**CULTURAL RESOURCES OFFICE
 PRESERVATION BOARD
 REGULAR MEETING
 MONDAY – OCTOBER 24, 2016 — 4:00 P.M.
 1520 MARKET ST. #2000
 ST. LOUIS, MO. 63103
www.stlouis-mo.gov/cultural-resources**

DATE: October 24, 2016
 ADDRESS: 1708-26 Park Avenue
 ITEM: Preliminary Review: Construct a three-story apartment building
 JURISDICTION: Lafayette Square Certified Local Historic District — Ward 7
 STAFF: Jan Cameron, Cultural Resources Office

DATE: October 24, 2016
 ADDRESSES: 2301-2335 S. Kingshighway Blvd.
 ITEM: Preliminary Review:
 JURISDICTION: Reber Place National Register Historic District
 Preservation Review District — Ward 8
 STAFF: Daniel Krasnoff, Cultural Resources Office

1708-26 PARK AVENUE

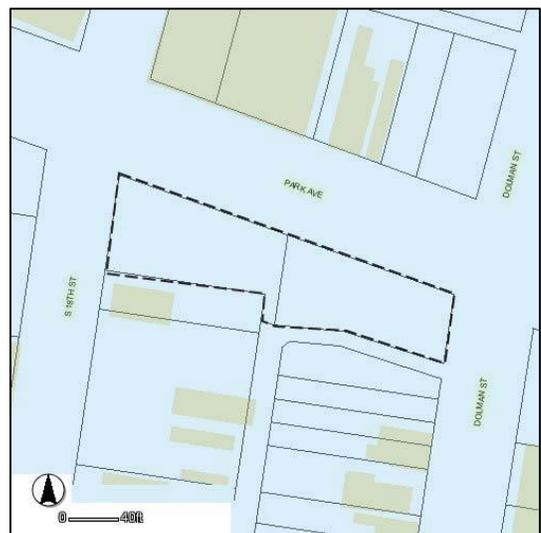
RECOMMENDATION:
 That the Preservation Board grant preliminary approval to the proposed new construction with the stipulation that details and specifications are submitted to the Cultural Resources Office for review and final plans and exterior materials are approved by the Cultural Resources Office.

The site plan meets the standards for alignment and setback.

No height comparisons have been submitted; the Mop Factory has a higher first story and parapet, although both buildings are three stories in height.

Fenestration on the proposed building does not follow the HME exactly, but instead presents a generic interpretation of 19th century factory buildings. The front elevation has recessed balconies which are not present on the Bouras Mop Factory.

Does not fully comply. The street elevations will be brick; the south elevation, which faces an adjacent residential property, will be clad with a different material that is yet to be determined. The brick will return a substantial distance at the southwest corner to screen the view from S. 18th Street. This secondary material will have only minimal visibility from the street.

Does not comply. There will be a secondary material on the rear elevation that is not reflective of the HME, which is entirely brick.

FRONT (PARK AVENUE) ELEVATION

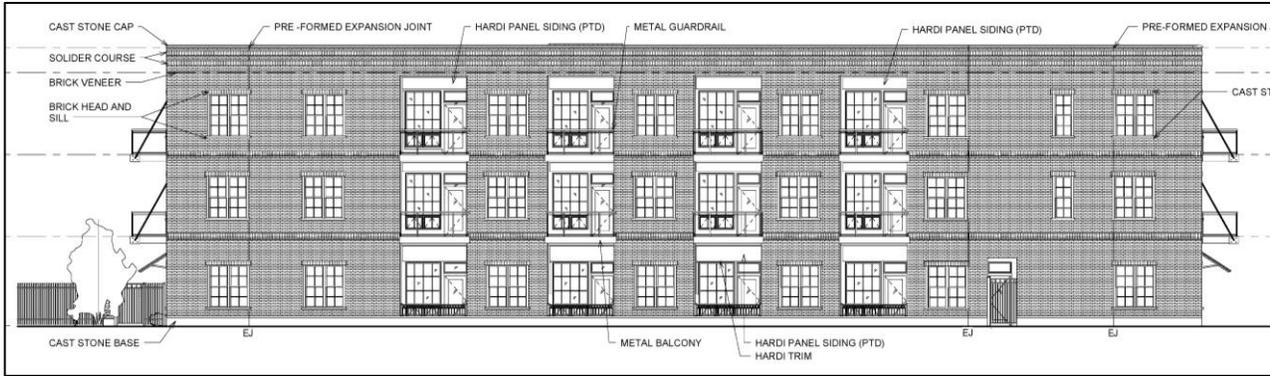
Windows of street elevations are similar to those of the HME.

The windows to be used on the façades will have paired under cast stone lintels. The windows will be approved by the CRO as to materials, dimensions and profiles similar to those of the HME, and have the correct brick mold.

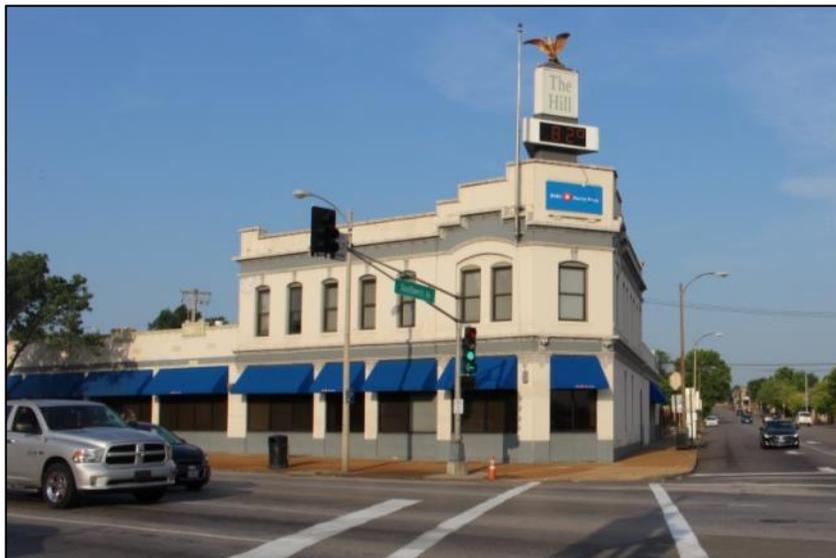
Because four of the five buildings/sections are contributing buildings to the Reber Place National Register Historic District, these structures are Merit Buildings per the definitions of the ordinance. The section constructed in 1973 is non-contributing.

1425 ANGELICA

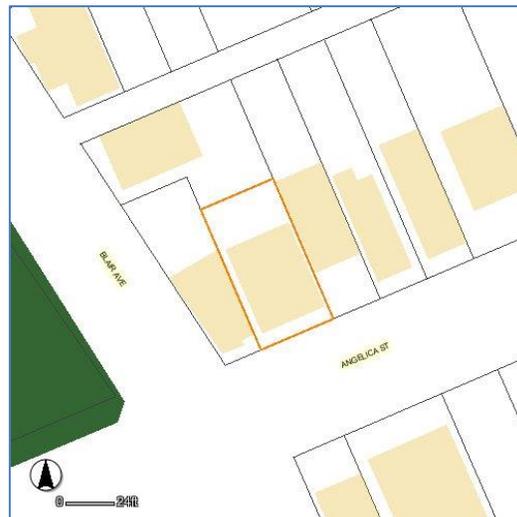
- 1425 Angelica is a contributing building to the Hyde Park National Register Historic District.
- It is a “Merit” building.
- The house has been condemned by the Building Division.
- The building is sound, in terms of the Ordinance.
- The severe deterioration of the building in combination with its questionable feasibility justifies approval of its demolition.

1429 ANGELICA (RIGHT)

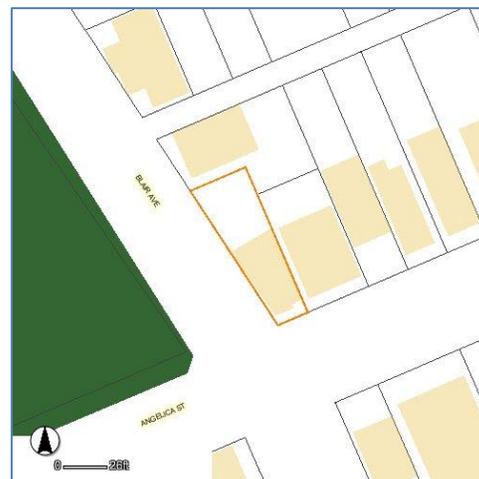
- 1429 Angelica is a contributing building to the Hyde Park National Register Historic District.
- It is a “Merit” building.
- The house has been condemned by the Building Division.
- The building is sound, in terms of the Ordinance.
- The severe deterioration of the building in combination with its questionable feasibility justifies approval of its demolition.

SIDE DOORS INSTALLED WITHOUT A PERMIT

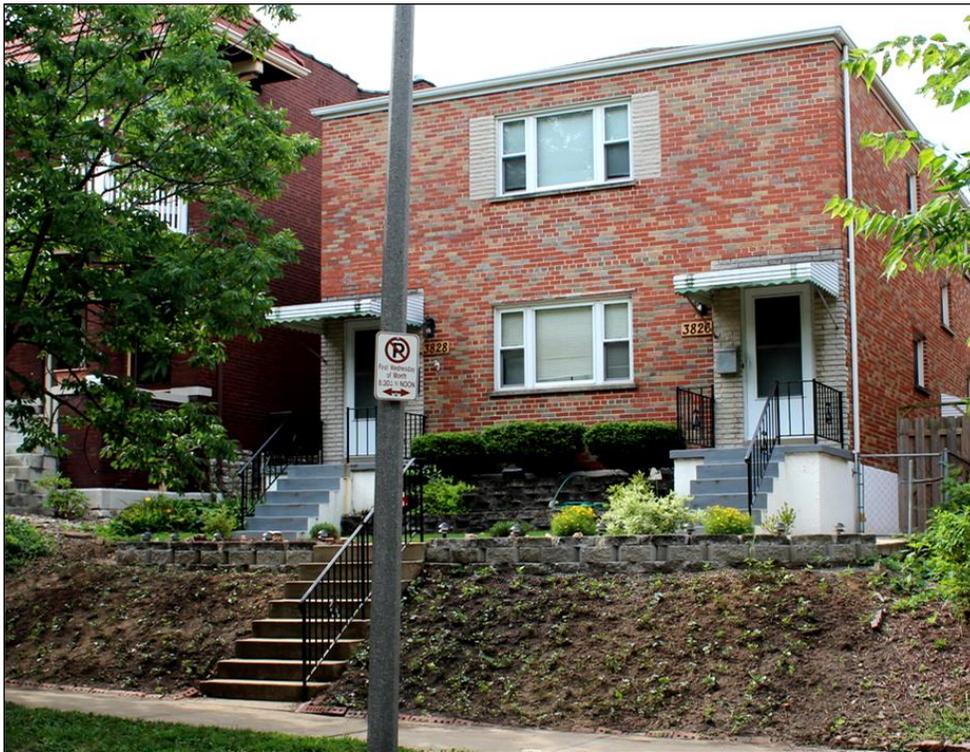
Based on these preliminary findings, the Cultural Resources Office recommends that the Preservation Board uphold the Director's approval of the application to retain side doors as the doors comply with the Compton Hill Local Historic District standards.

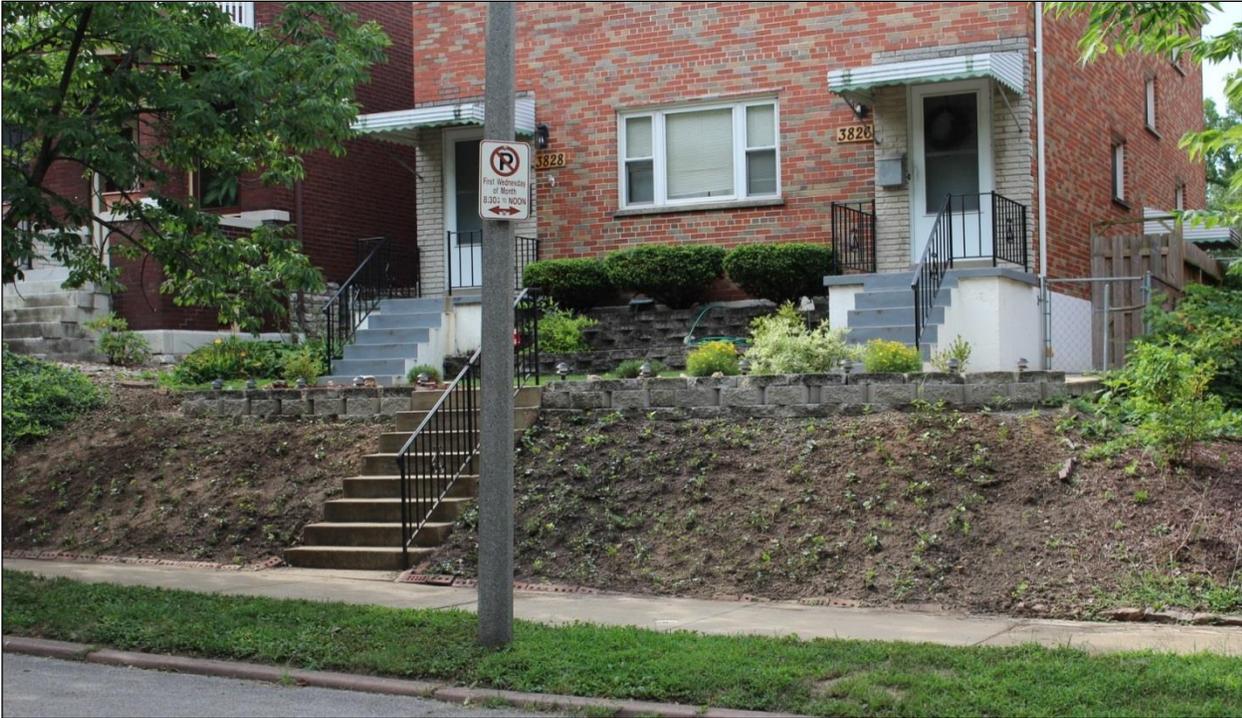
Does not comply. The proposed retaining wall would be constructed with concrete units which is not an approved material under the historic district standards. The wall sits in front of the building line which is also not allowed under the standards.
